CU Certification of Completion

CU BACKFILL/ENGINEERED CAP COMPLETION APPROVAL - FORM 2						
Reporting Date	11/19/2009				Placement Start Date	10/15/2009
CU Number	3				Placement End Date	11/10/2009
Approximate CU Centroid	Northing	1614048	Easting	736253	NY State NAD 83	
CU Size	4.87	Acres				
Backfill Area	3.55	Acres*				
Cap Area	1.32	Acres				
Backfill Surface Mean Tri+ PCBs Concentration (when required)		NA		mg/kg		
Number of nodes sampled		NA		mg/kg		
Backfill X	Type of Backfill Type 1, Type 2, Nearshore, 15%	Reference to appropriate drawings attached to Approval Form 1 CU3 Backfill and Cap Plan, 10/13/09				
Cap X	Type of Cap Type "A" Low Velocity Cap and Type "A" Medium to High Velocity Cap	Reference to appropriate drawings attached to Approval Form 1 CU3 Backfill and Cap Plan, 10/13/09				
CU Checklist		Indicate one of the following			Reviewer Initial Acceptance

Narrative Summary of Backfill and Capping and EPA Backfill and Capping Agreements

CU03 - POST BACKFILL PLACEMENT
HUDSON RIVER, NEW YORK
HUDSON RIVER SEDIMENT REMEDIATION PHASE 1 PROJECT

DRAWING NO: CU6-2
JOB: 442209.01-01

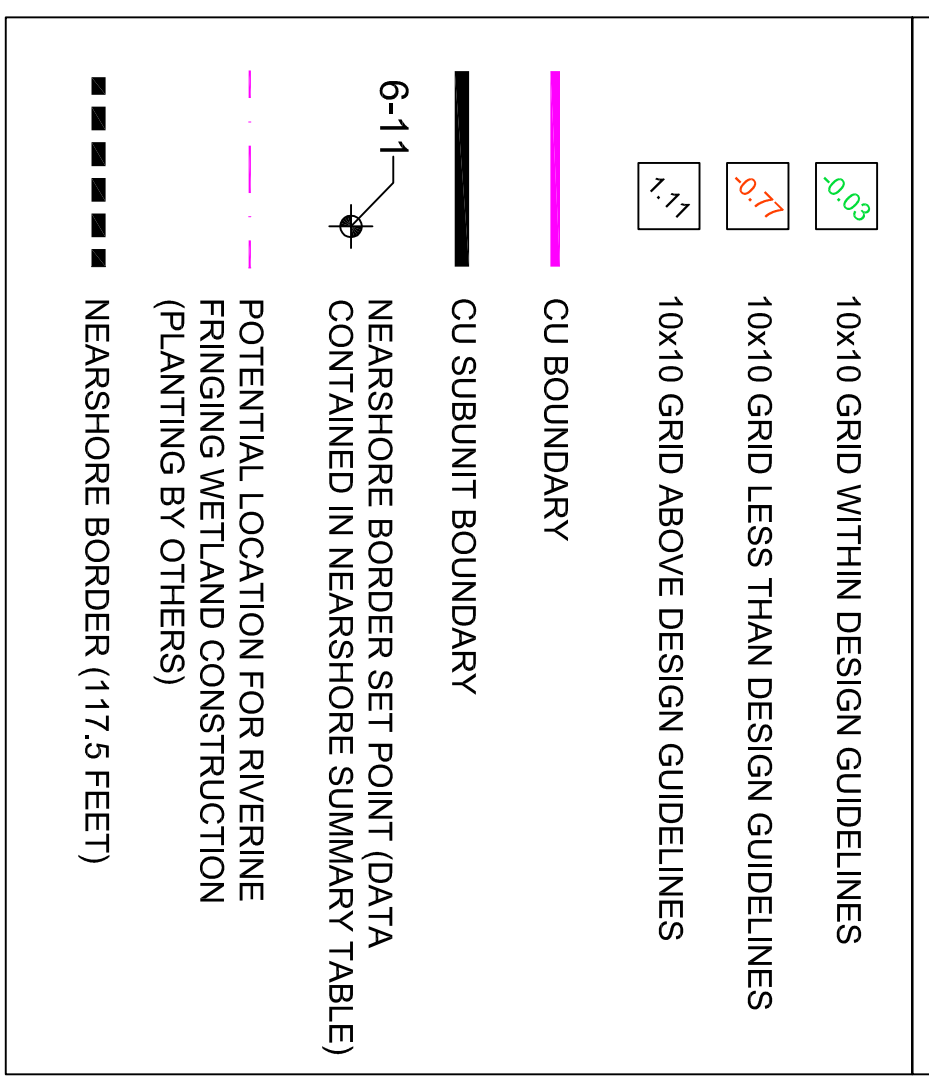
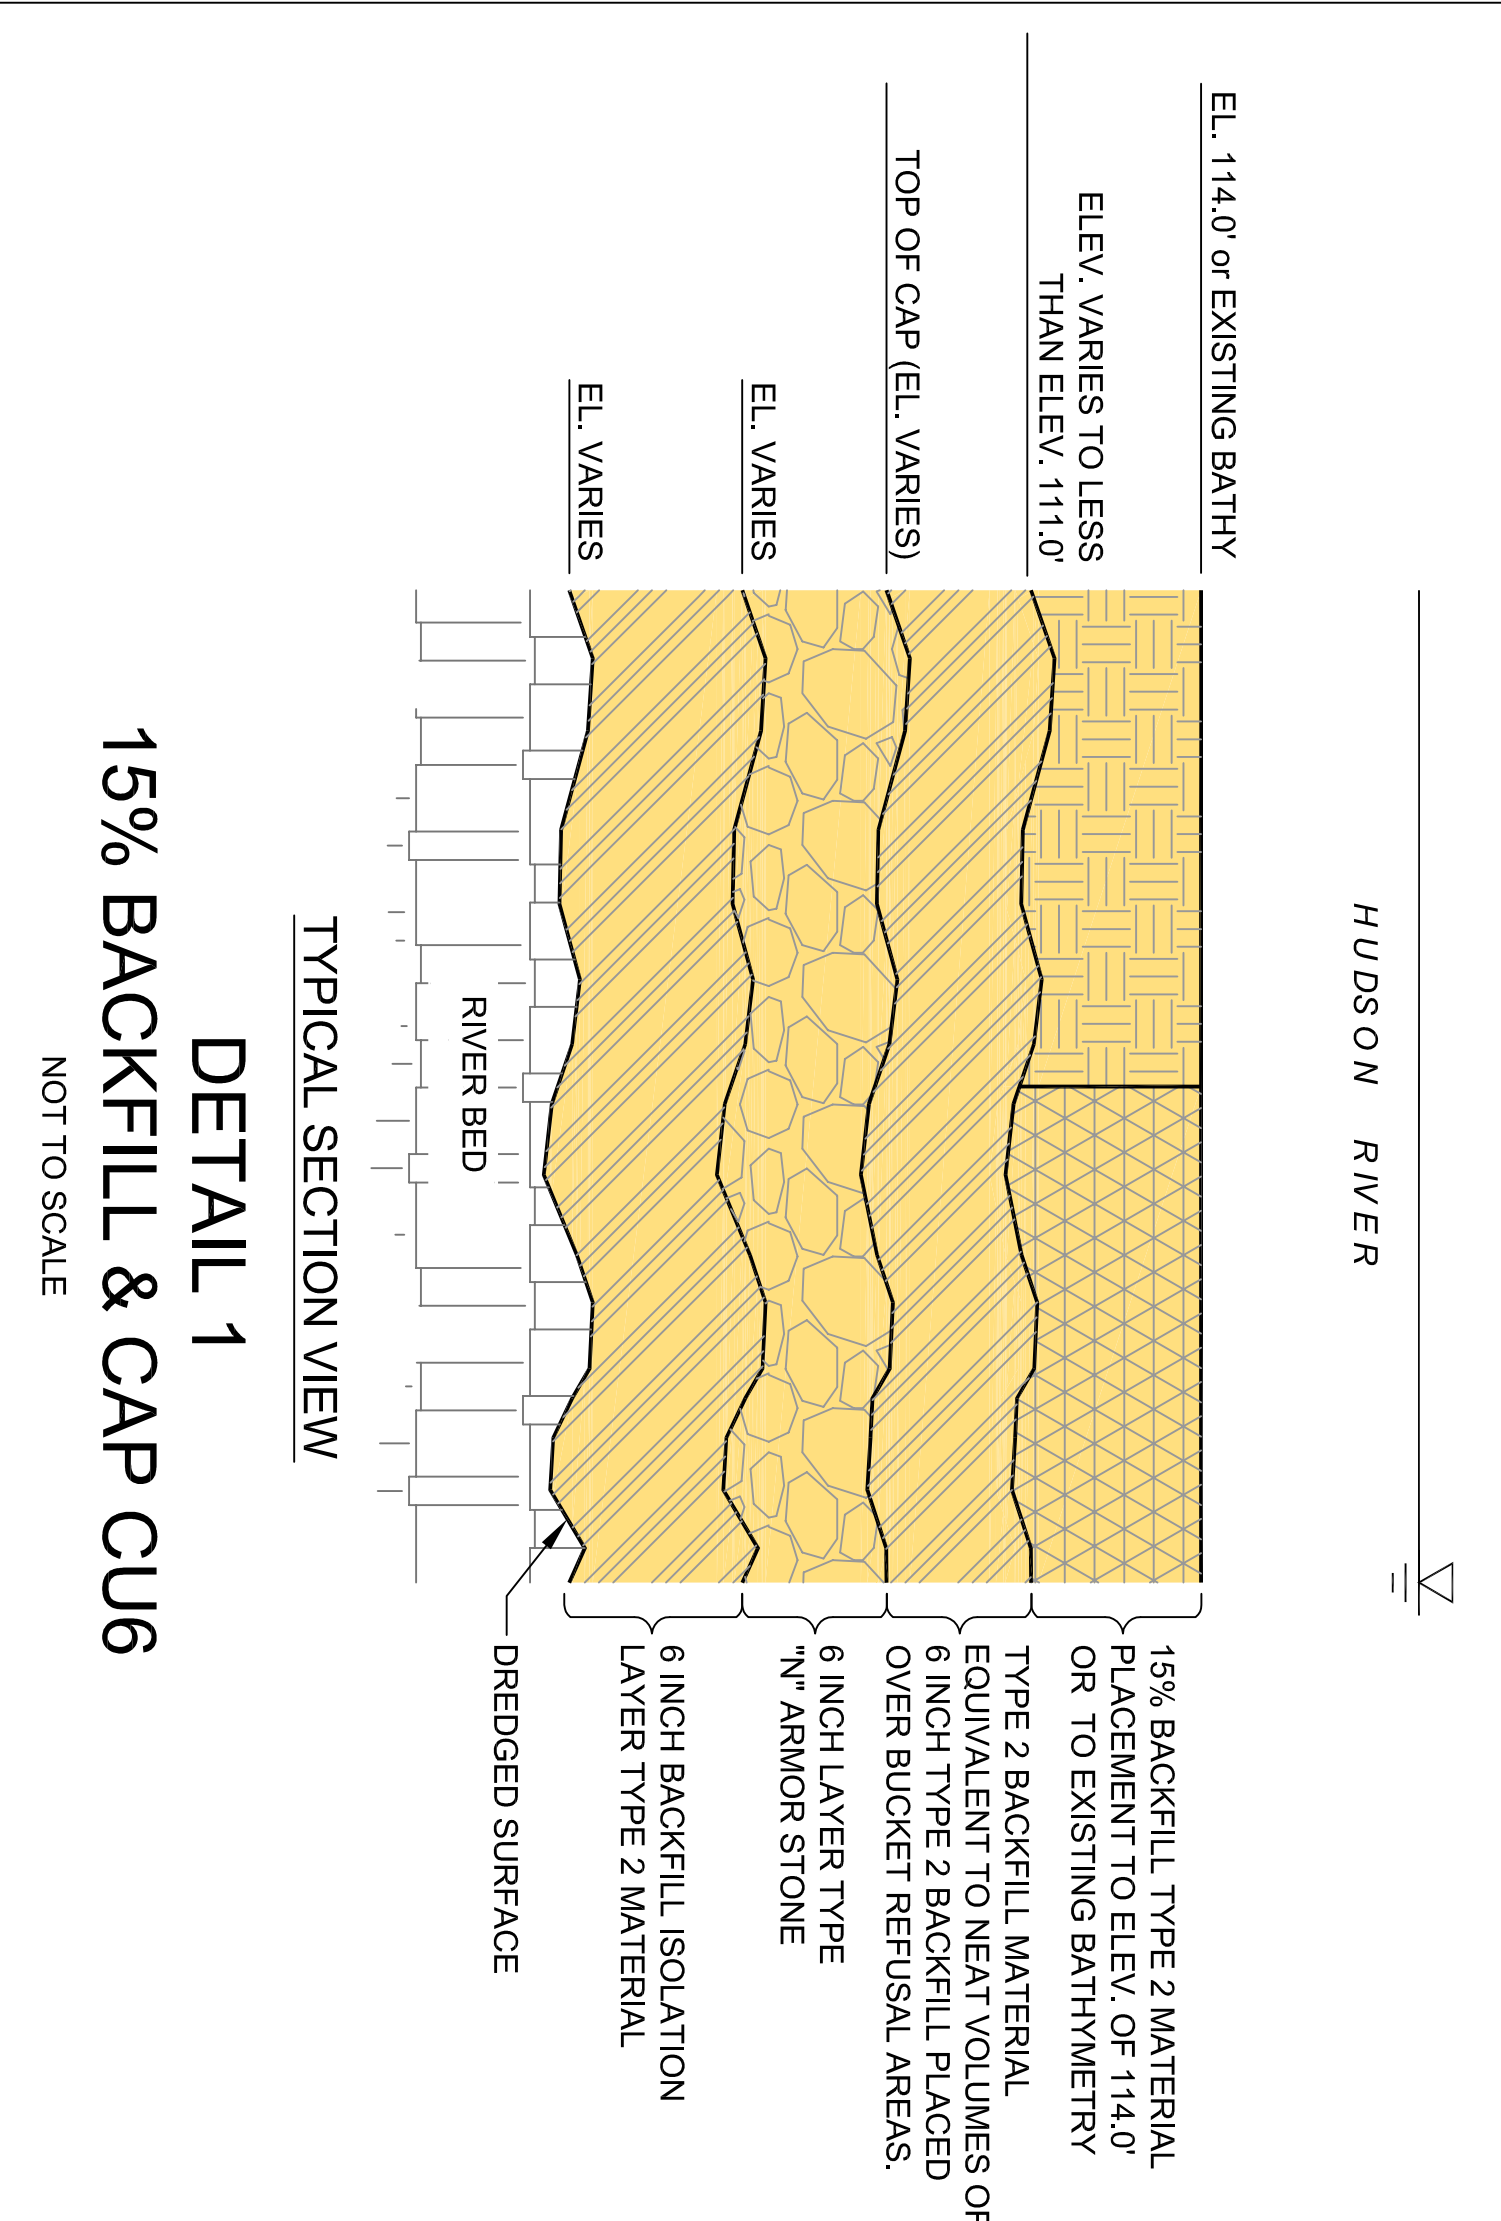
4. During the 4:00 PM meeting on October 23, 2009, GE presented acceptance surveys of the top of backfill elevations in CU6. Based on the information presented by GE, EPA indicated additional backfill placement is required in the southern portion of CU6 near the NYS Route 197 bridge piers. On October 23, 2009, GE directed the Dredging Contractor to place additional backfill in this area, and a third party multi-beam survey of this area was completed on October 24, 2009. The Backfill Acceptance Survey Drawing, dated October 25, 2009, included in this package, reflects the new survey data.

REV/	DATE	DRN BY	DRAWING DESCRIPTION	DRAWING TITLE
2	10/26/09	JHG	REVISED PER EPA COMMENTS	MG
1	10/25/09	JHG	OSI MULTIBEAM SURVEY #2 - ISSUED FOR EPA REVIEW	MG
0	10/23/09	JHG	OSI MULTIBEAM SURVEY #1	MG
			DRAWING DESCRIPTION	PM
